Commission Agenda Report

Planning Commission Meeting
09-22-26
Item 3.B.5.

Subject: De Minimis Waiver No. 26-005 – An application for a new pool and spa to be used for fire suppression purposes for a parcel affected by the Woolsey Fire

Revised[1] De Minimis Waiver

POOL PLAN AND DETAILS

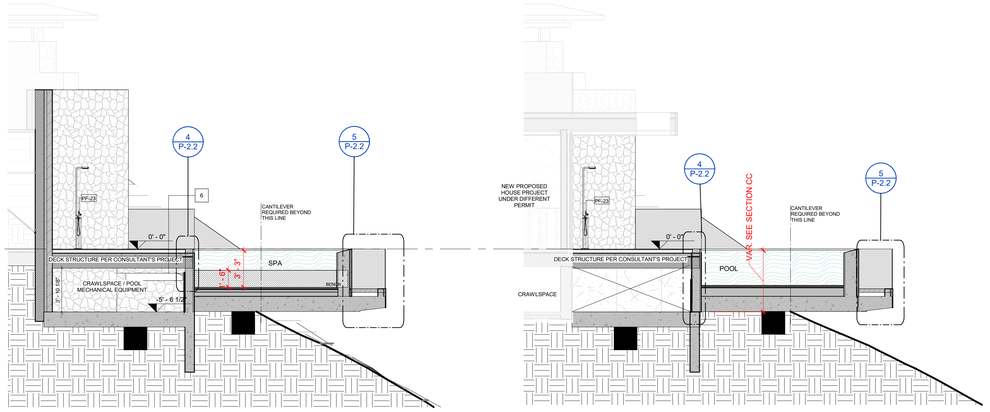
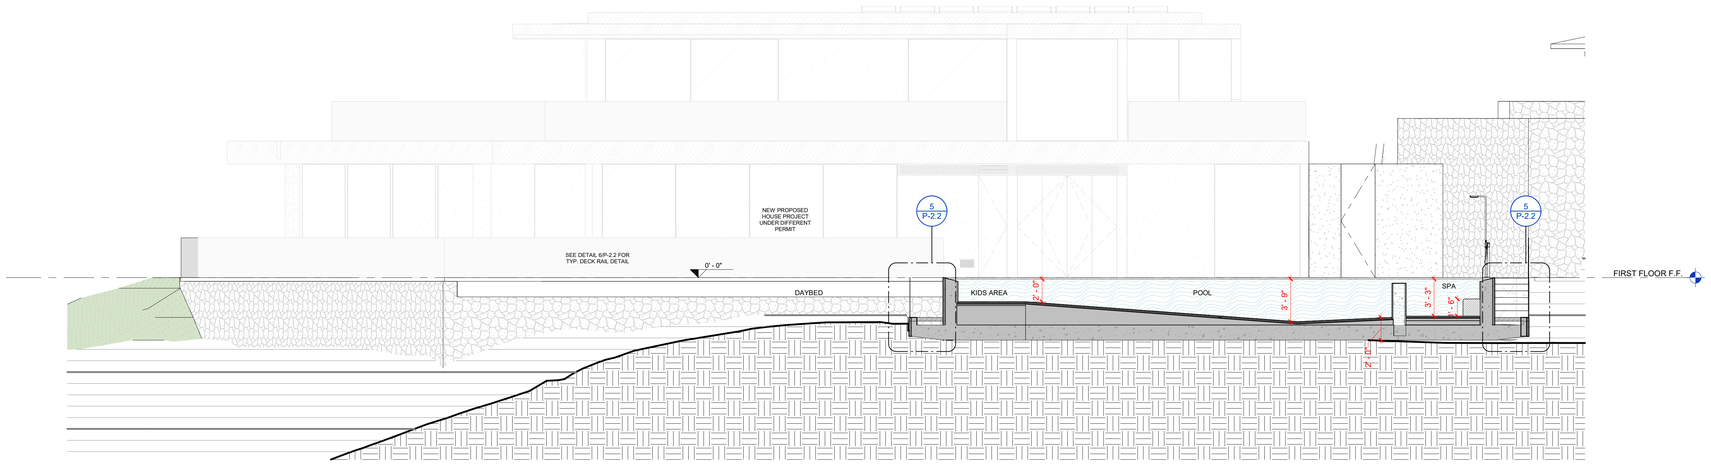
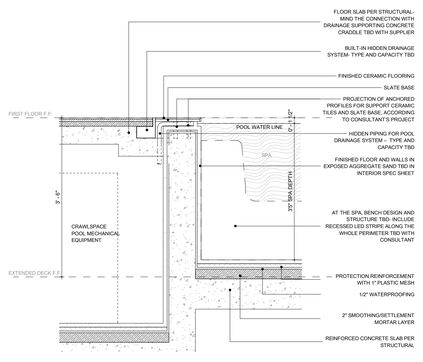
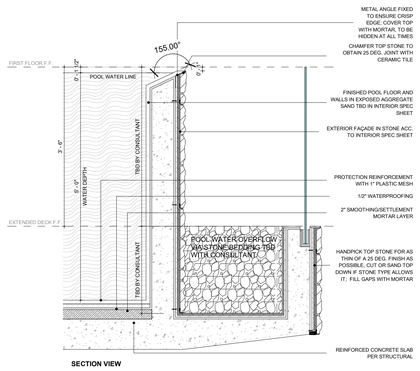
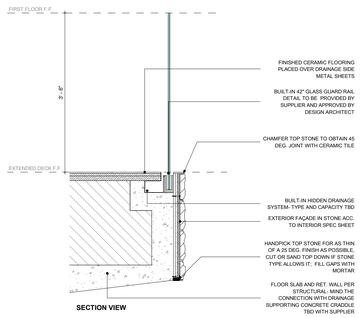
22. Sheet P-2.1 of the Studio Arthur Casas plans dated 6-9-2025 depict a proposed outdoor shower. A note shall be incorporated into the project plans stating: “The proposed outdoor shower shall not drain to the existing onsite wastewater treatment system (OWTS).”

4) **Proposed Pool Shower Note:** Sheet P-2.1 of the Studio Arthur Casas plans dated 6-9-2025 depict a proposed outdoor shower. A note shall be incorporated into the project plans stating: "*The proposed outdoor shower shall not drain to the existing onsite wastewater treatment system (OWTS).*"
